FARR WEST CITY COUNCIL AGENDA

RE: **FARR WEST BUSINESS PARK SUBDIVISION & SITE PLAN**
Final Plat and Site Plan Review

FARR WEST BUSINESS PARK
A 4 LOT COMMERCIAL SUBDIVISION
PRELIMINARY PLAT

**Proposed
Site Plan**

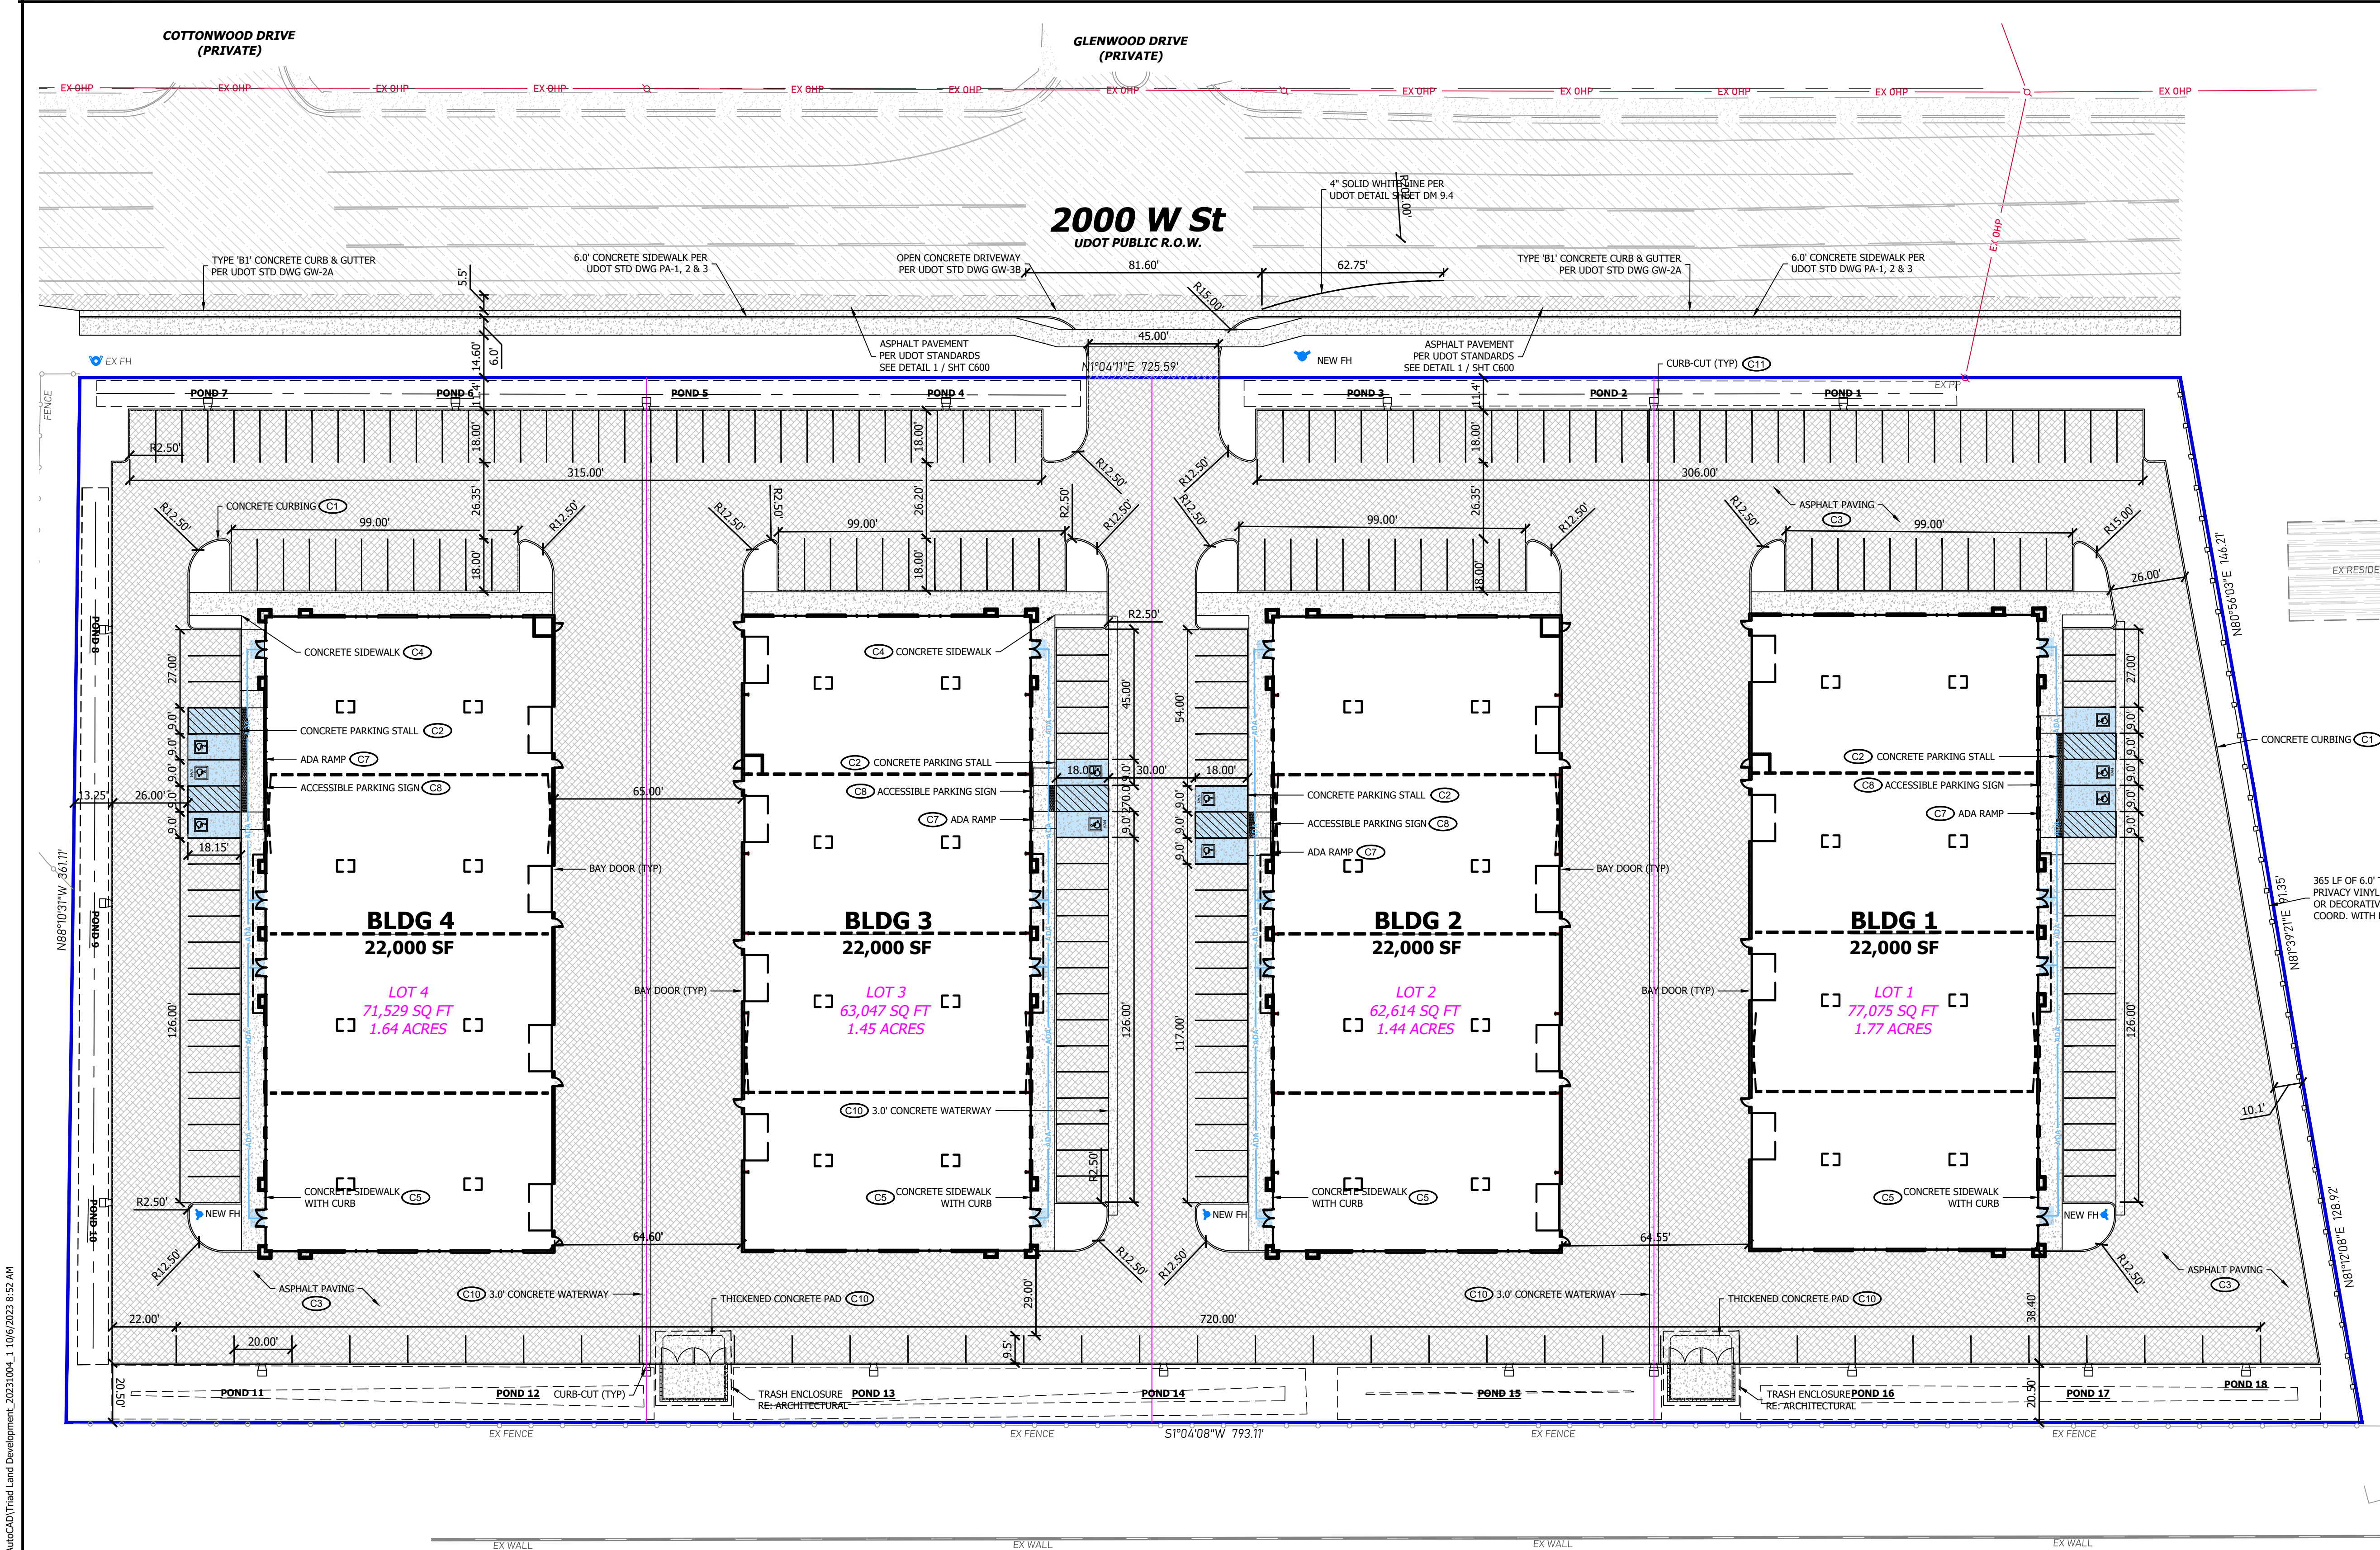
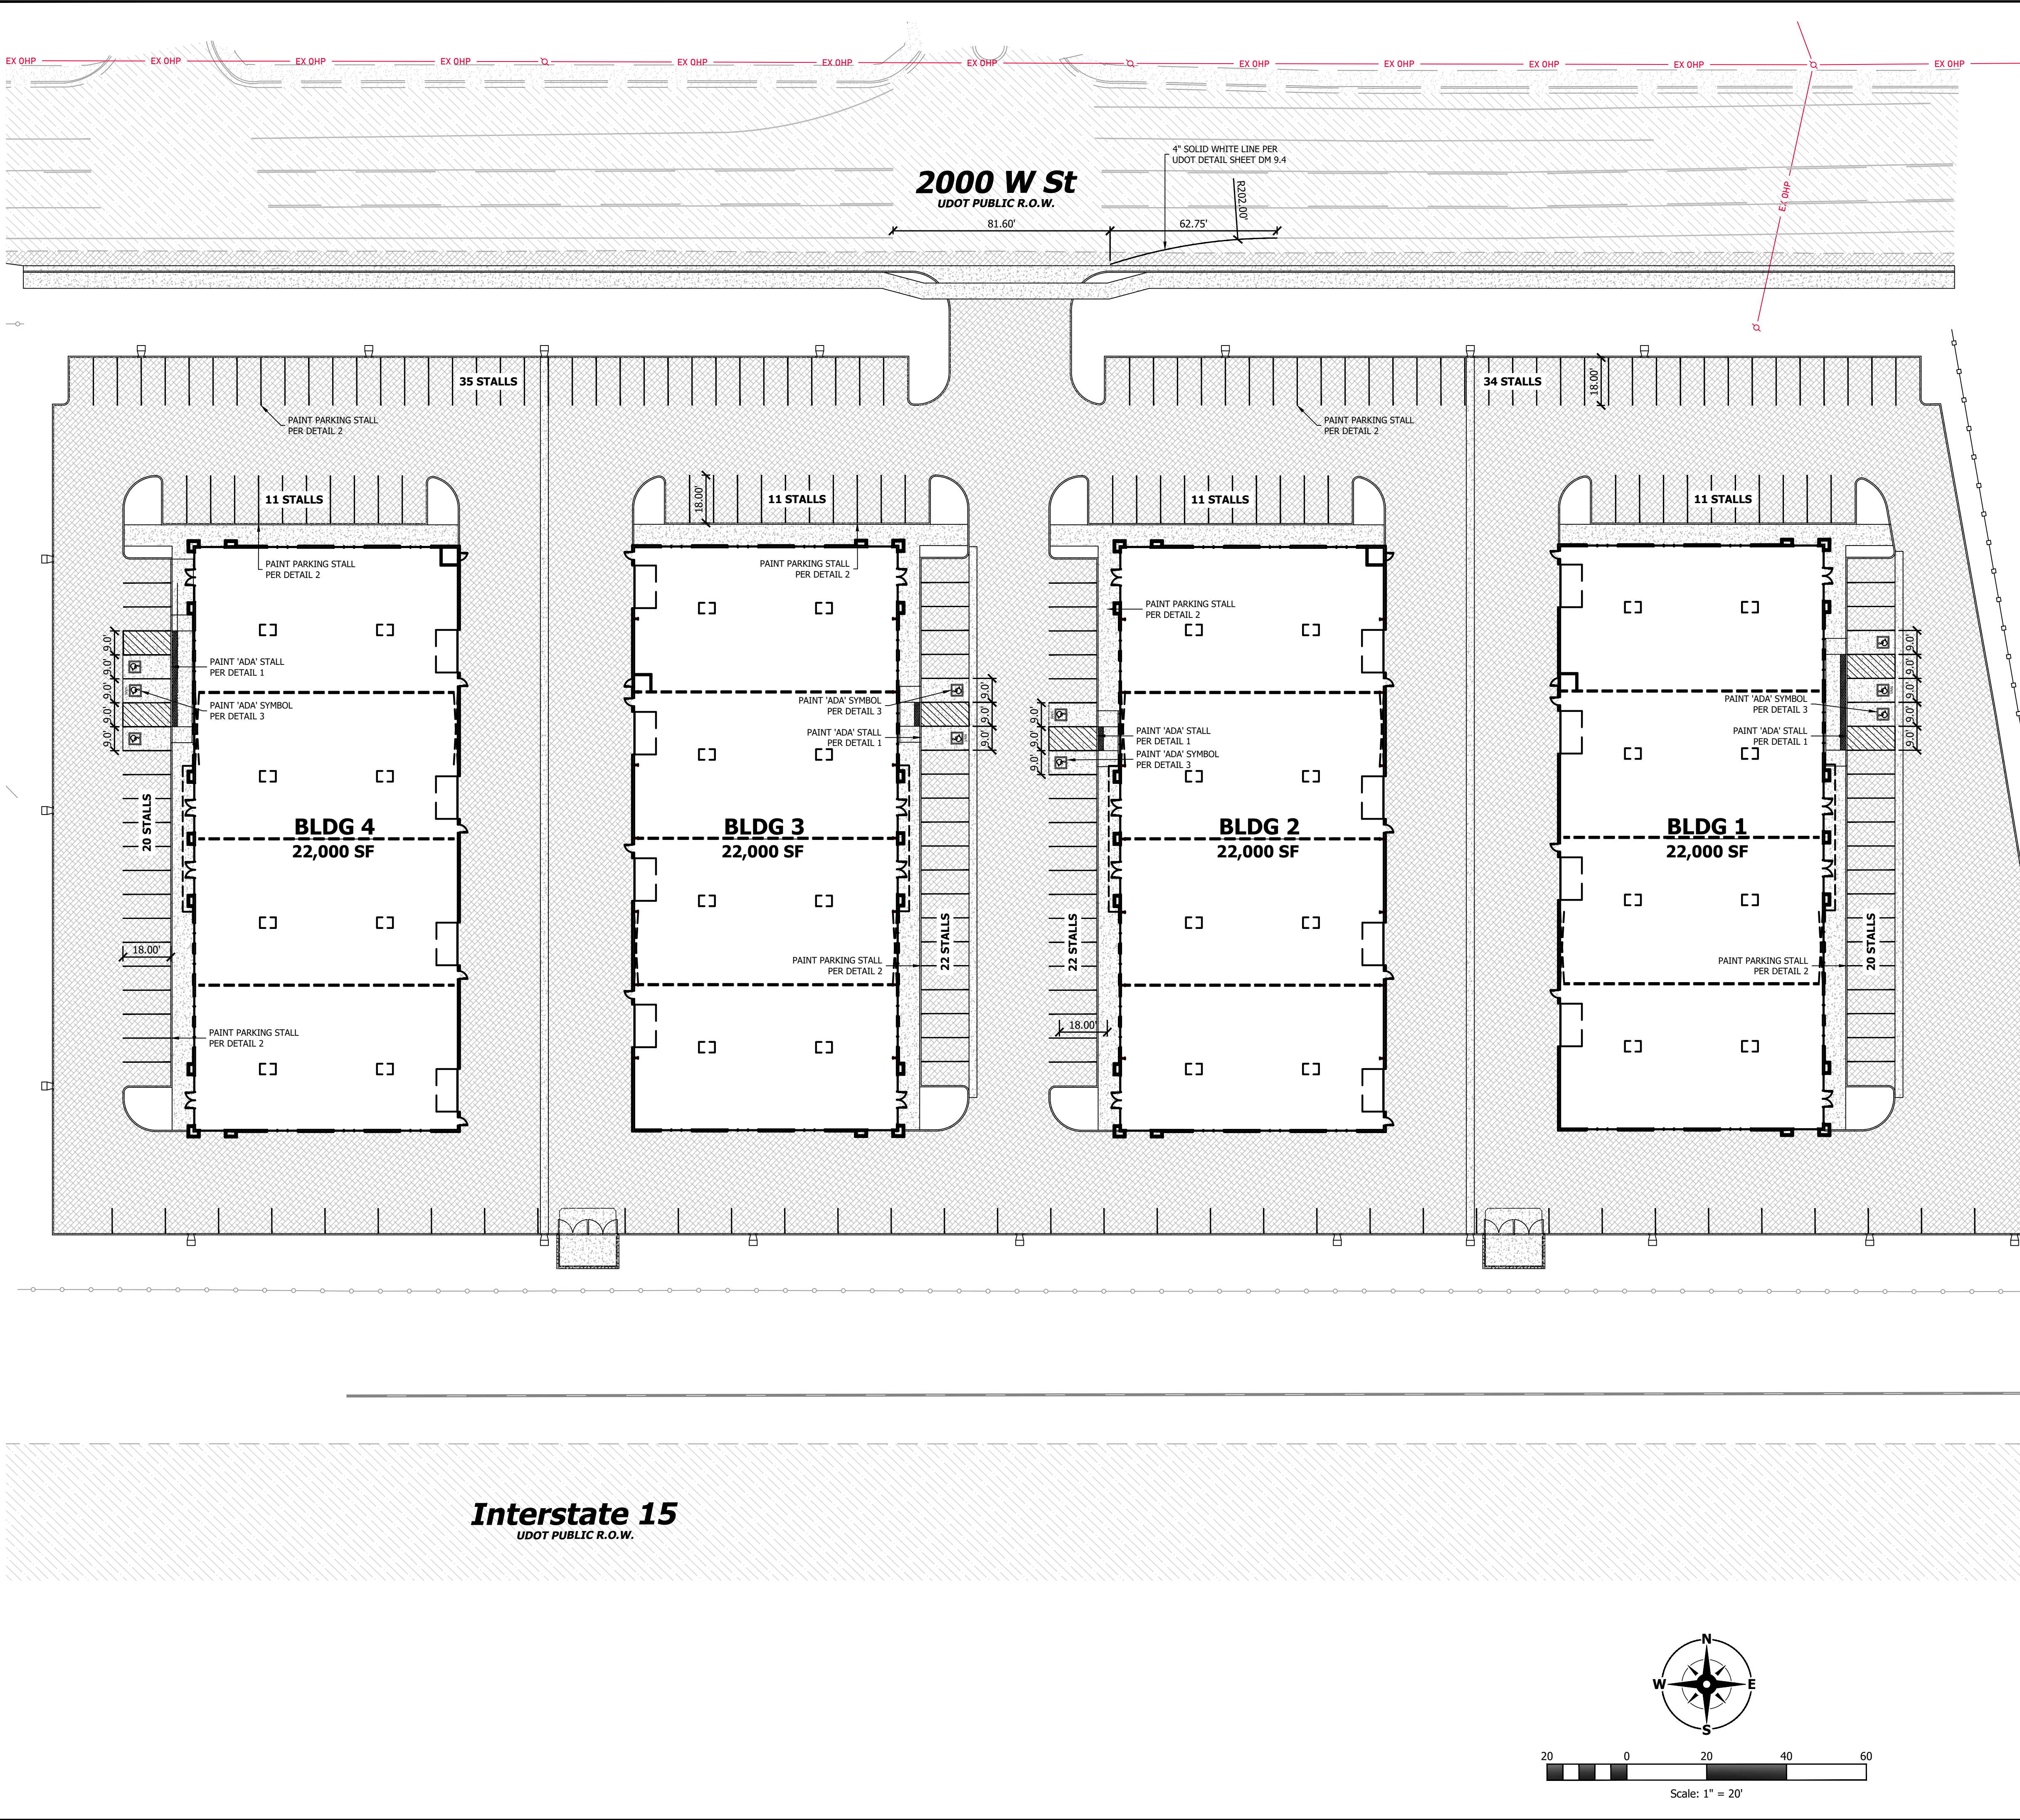
Specific Comments: **The rear of each space will probably require a man door. Please verify with the building official.**
